Millbury Planning Board Site Plan Review Continuance Raymond E. Shaw Elementary School Project

Millbury, MA | Millbury Public Schools
July 20, 2020

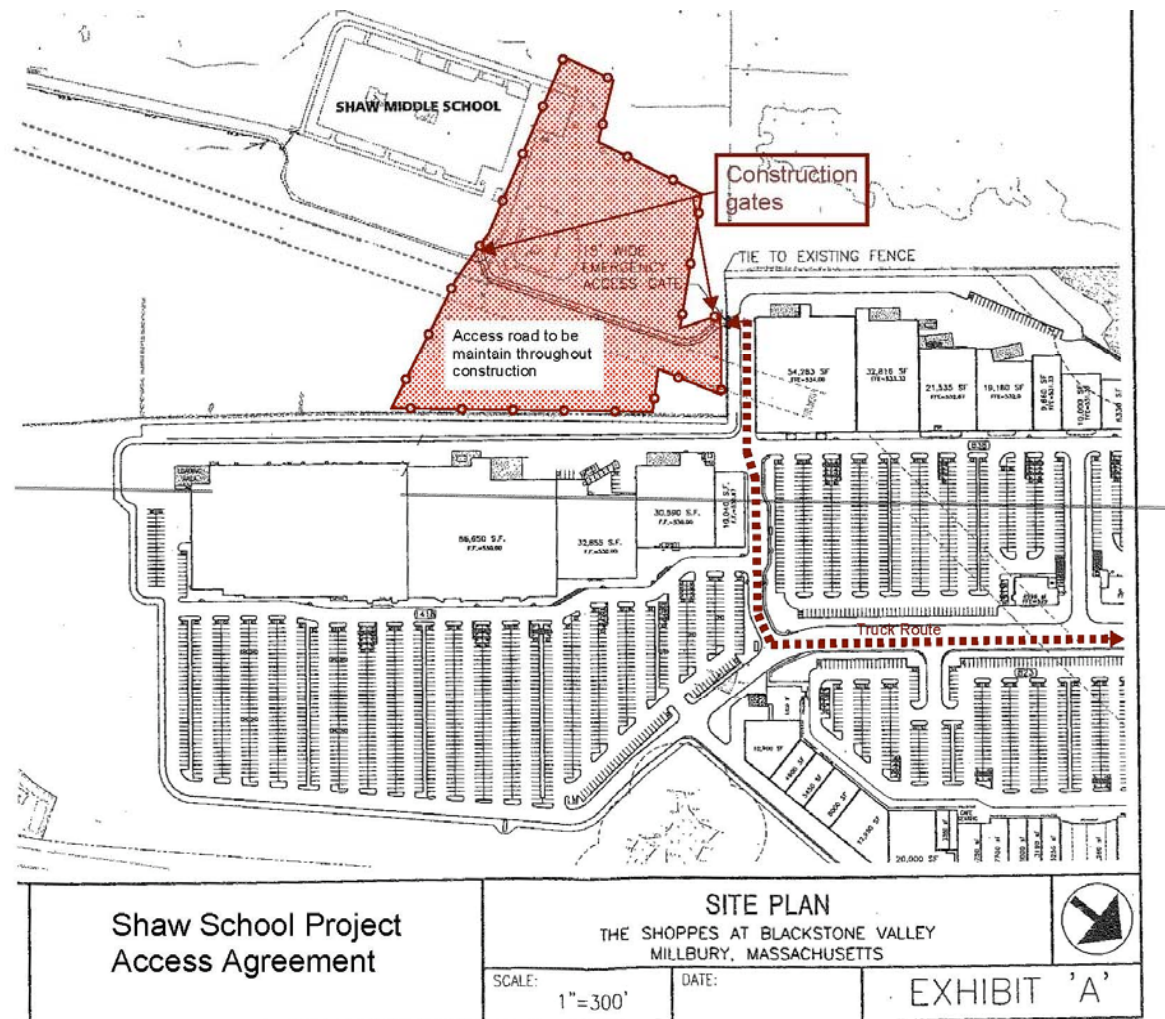
- What will the vehicle flow and volume be through the Mall during construction? What is the status of the agreement with the Mall for that access?

The Project OPM is working with the Mall Ownership. A draft contract has been generated and is in the process of being reviewed by all parties, including specific language and routes for construction access through the Mall.

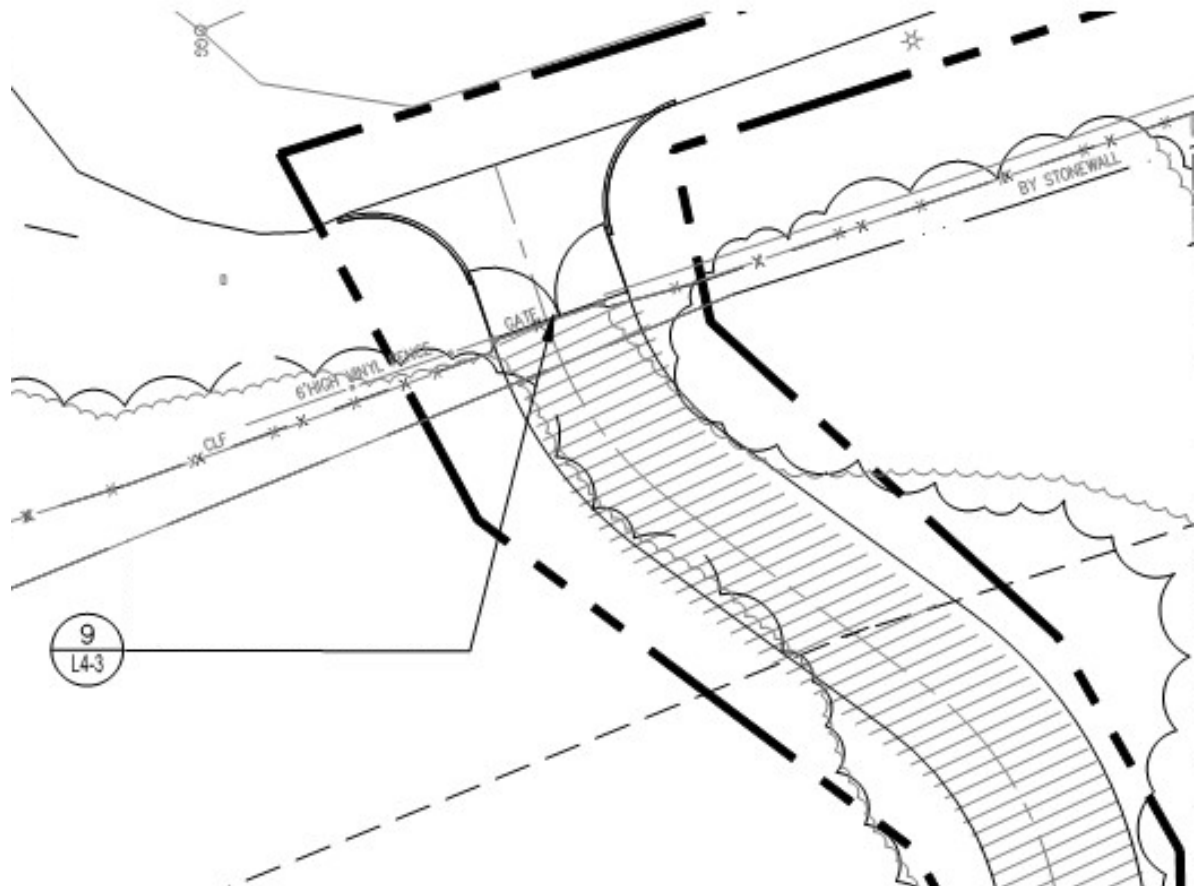
- What will the future state of the emergency access be? How will it be controlled?
 - Access controlled by MFD and MPD
 - New 6' tall gate is proposed similar to existing
 - Covered by a security camera.
 - New light will maintain a low level of illumination

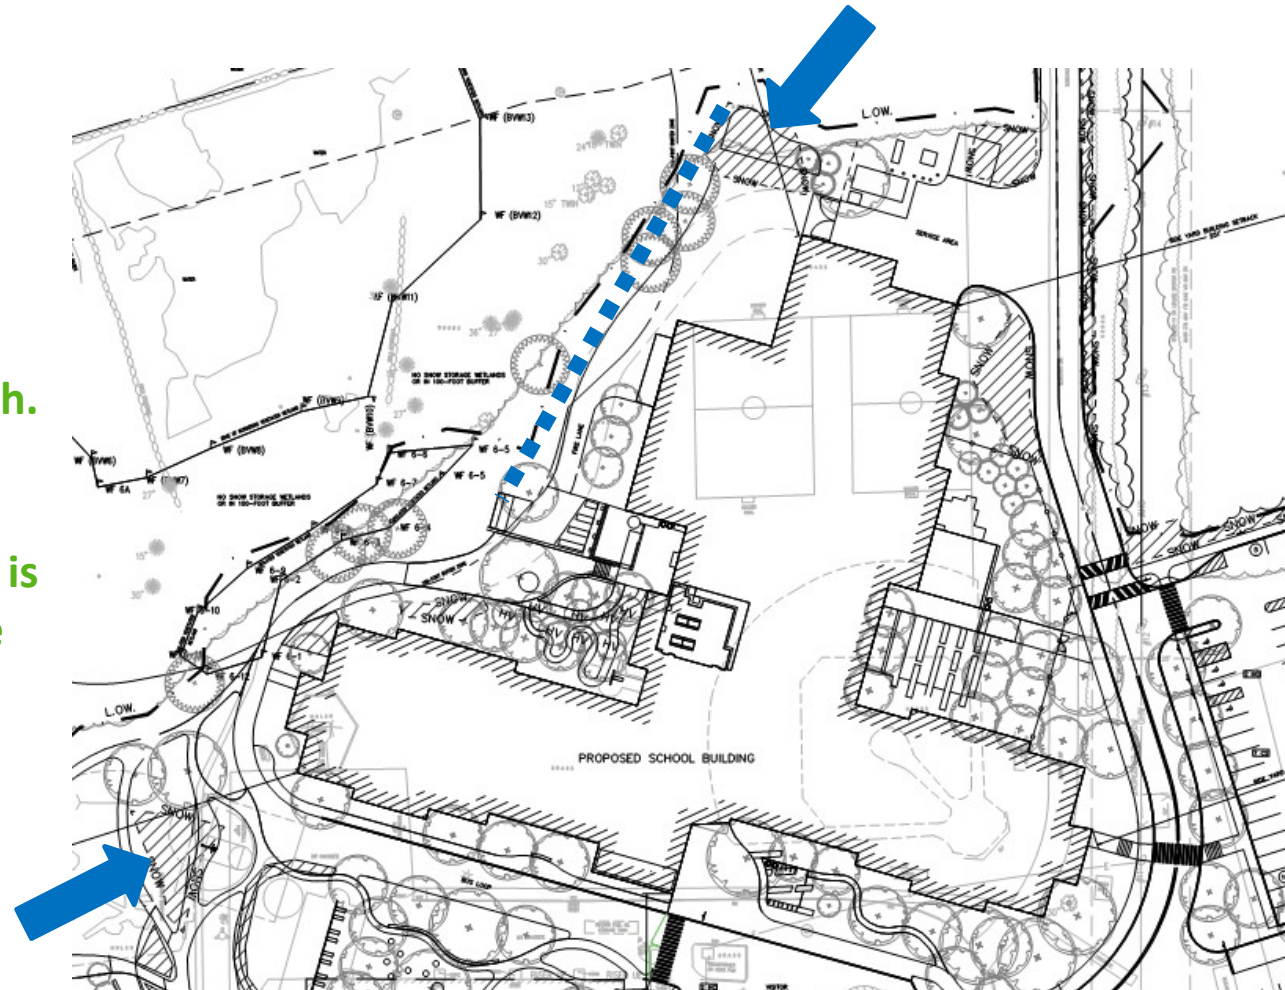
- Is there sufficient snow storage for the fire lane on the west side of the proposed school?

Snow storage requirements are minimal for the fire lane, and adequate space has been provided to the north.

Additional snow storage to the south is possible for extreme storm events.

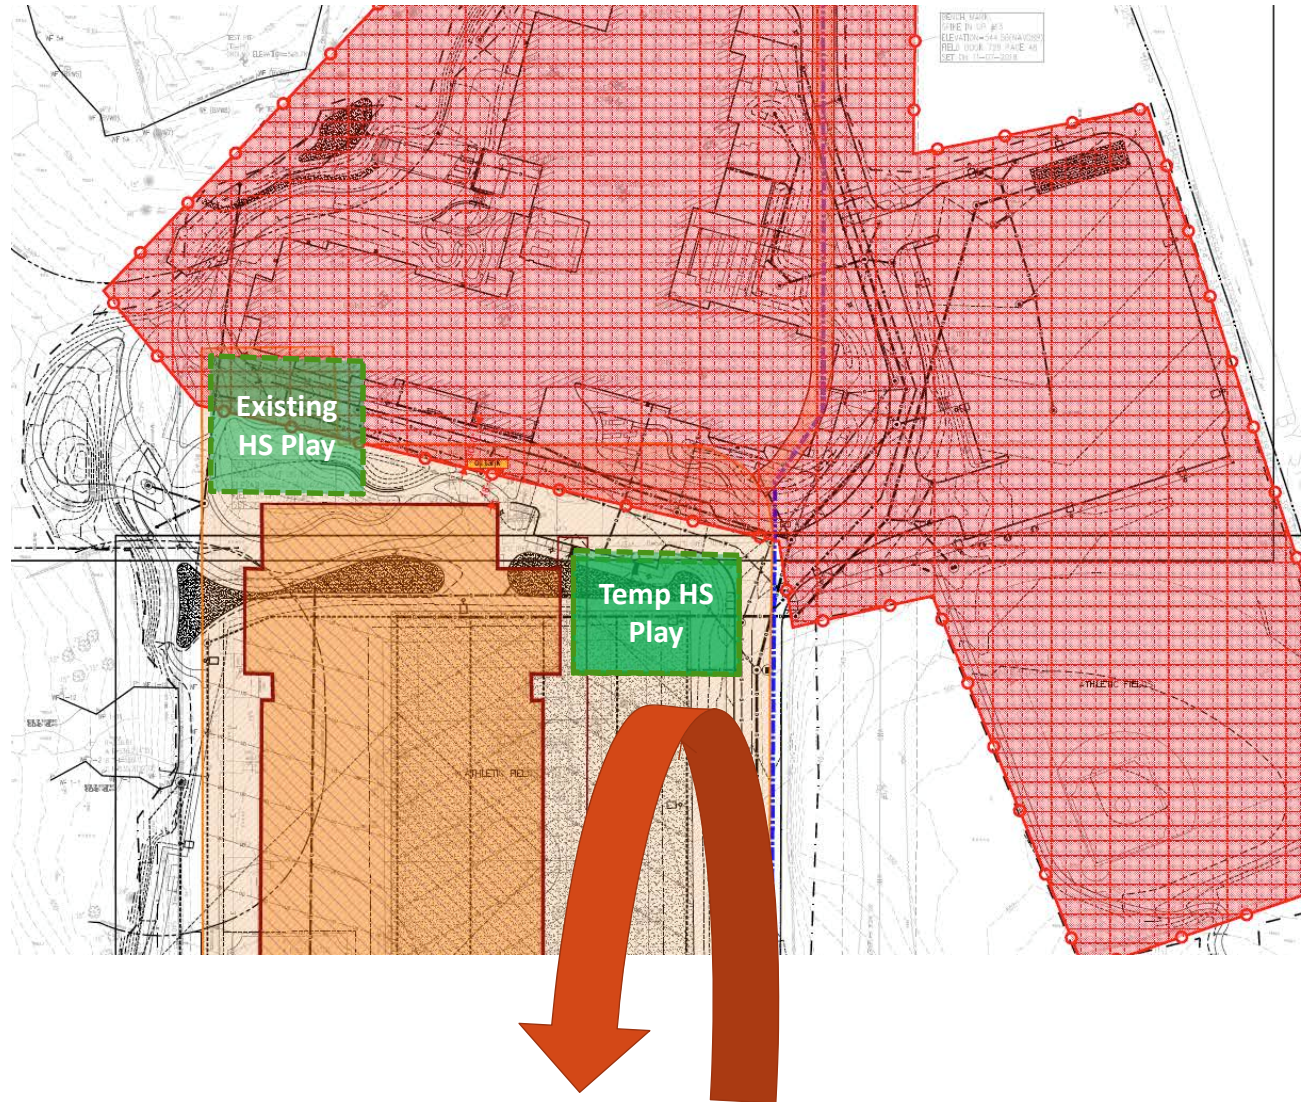
- 417 Greenwood St, to the north, is for sale. What is the impact to the school project?

The adjacent site has significant slope (continuation of the slope west of the existing school) and includes major wetland and streams and adds no value and has not impact to the school project.

The proposed building meets all zoning set back requirements and therefore presents no impact to the adjacent site.

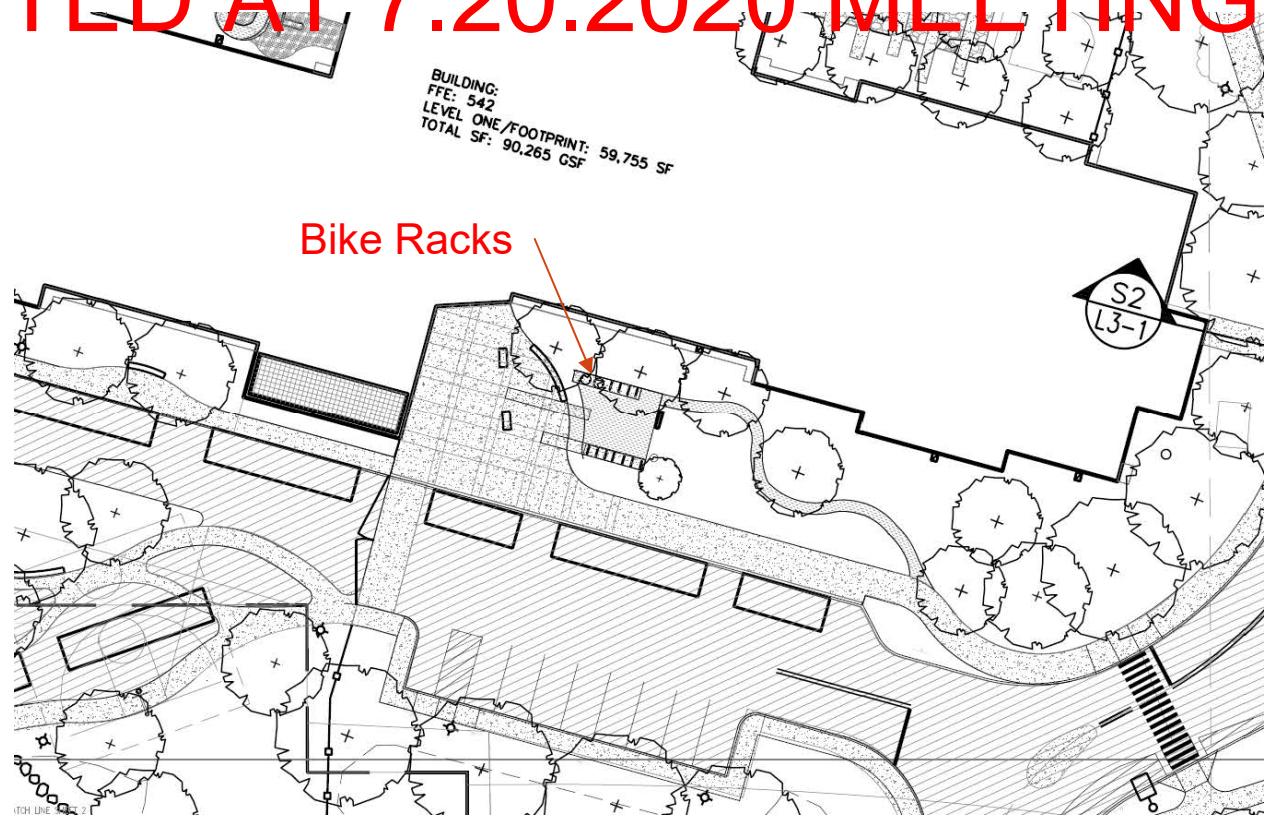
Town Planner Question #14 | BICYCLE ACCESS

The proposed driveway will include sharrows along the entrance driveway from the intersection of Elmwood to the top of the driveway

Bicycle storage is accommodated adjacent to the main building entry where shown on the plan.
